**GULF STATES UTILITIES COMPANY**

March 6, 1984

River Bend Station - Unit 1  
Docket No. 50-458

Enclosed for your review are Gulf States Utilities Company responses to the open items identified in the Draft Safety Evaluation Report by the Auxiliary Systems Branch and responses to the request for additional information identified in part by Staff letters dated August 5, 1981 and December 31, 1981. This letter supplements docketed correspondence from Mr. Booker to Mr. Denton dated December 1, 1983, December 30, 1983 and February 2, 1984. Attachment 1 summarizes the open items and indicates changes to be made in the River Bend Station FSAR. Attachment 2 provides a brief discussion of each open item, the response and reference material for each item. Where indicated, these responses will be provided in a future amendment to the FSAR.

FIGURE 9.1-8

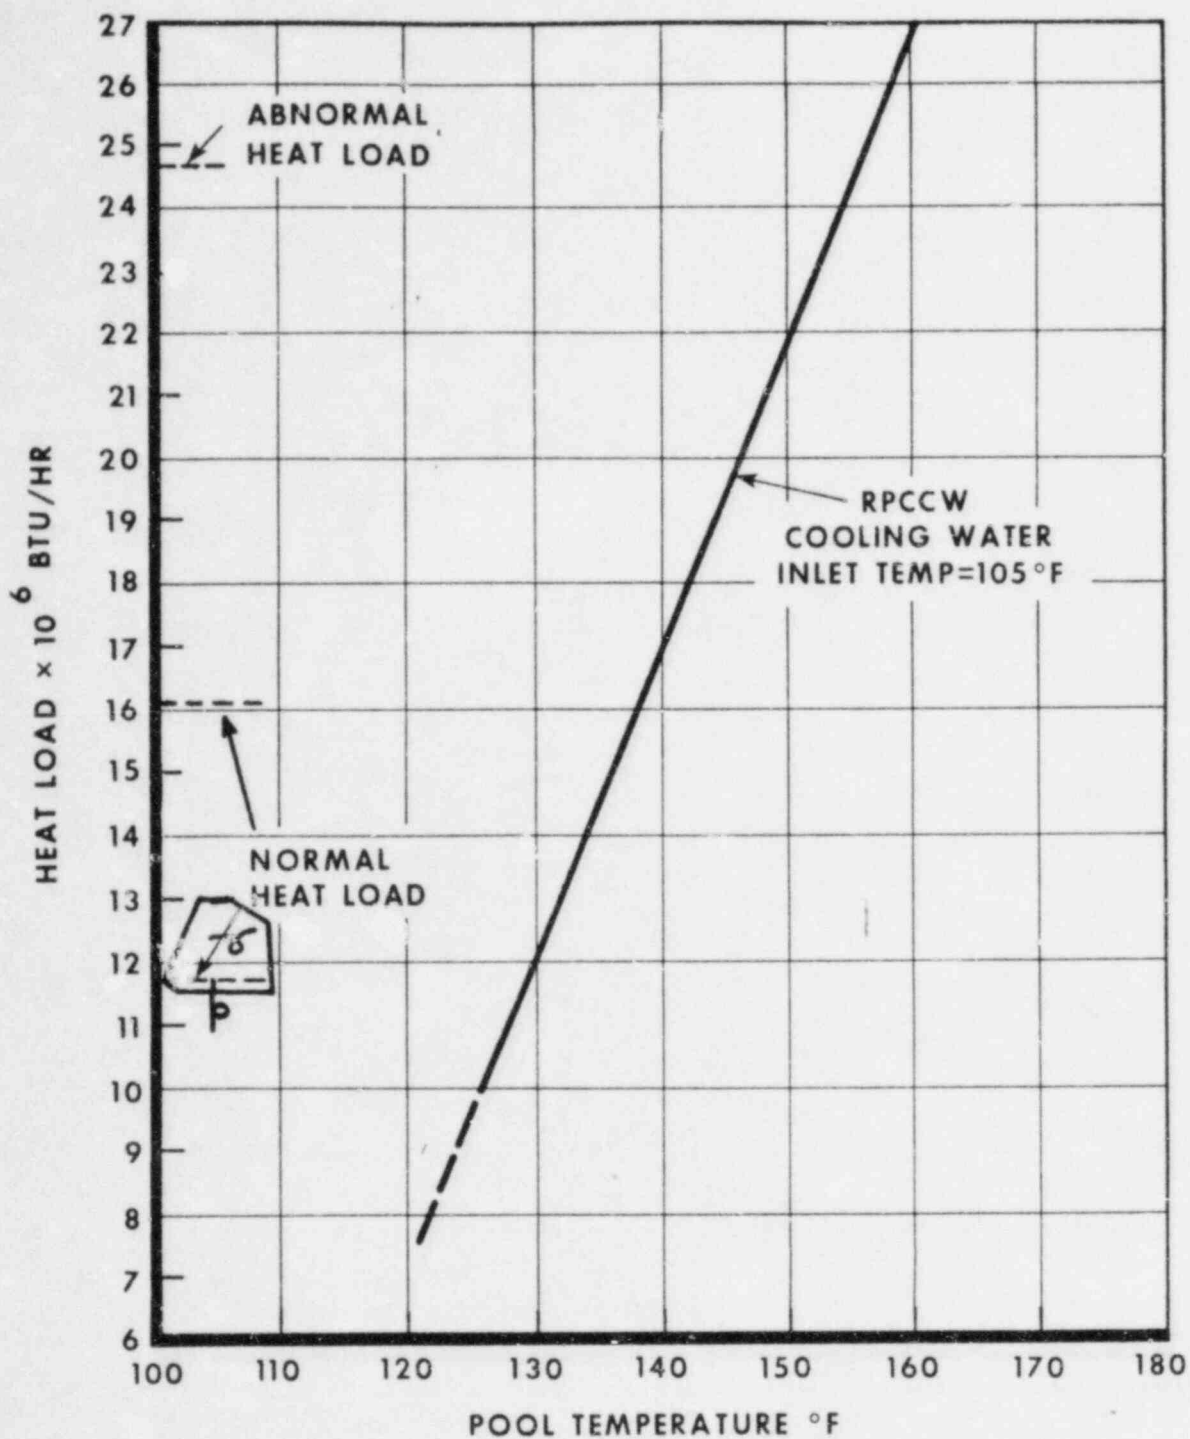
- 9a. The applicant should provide the number of fuel bundles and frequency assumed for "normal" refueling so that the heat load calculations for the spent fuel pool may be verified.

RESPONSE

Assumptions and results of the design heat load calculations for the fuel pool cooling system are provided in revised Section 9.1.3.1.1, Tables 9.1-5 and 9.1-8, and Figure 9.1-8. (See Enclosure 3.) These revisions reflect the heat inputs of an eighteen month refueling cycle which provides a more conservative design basis than any shorter refueling cycle.

4. The fuel pool cooling subsystem is designed to remove the decay heat from the combined fuel storage pools' capacity at a rate sufficient to maintain the temperature of the water at or below 156°F, when 508 percent of an equilibrium core is stored in the pools (Fig. 9.1-8). The calculation of the water temperature for this abnormal load with the storage of 508 percent of an equilibrium core was based on the following:

(See Table 9.1-8). The heat load imposed on the spent fuel storage pool by assuming an 18-month refueling cycle envelopes (i.e., is higher than) the 12-month refueling cycle case.
